Notice of Allowability

10/084,580

TRIPATHI ET AL.

Figure 3
(Prior Art)

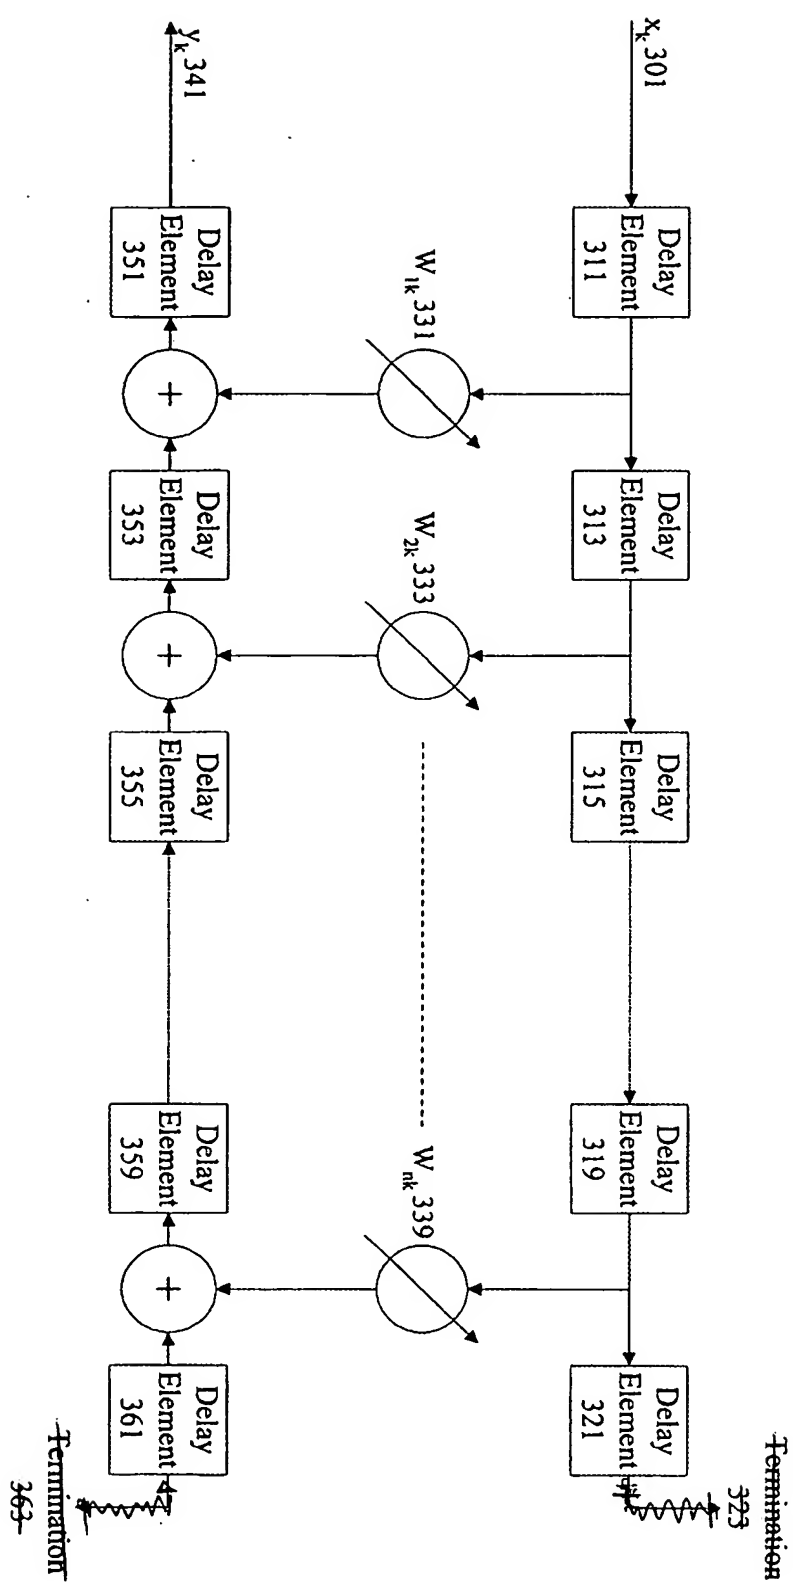
The following changes to the drawings have been approved by the examiner and agreed upon by applicant:

Figures 3 and 4 have been changed as marked in red.

In order to avoid abandonment of the application, applicant must make these above agreed upon drawing changes.
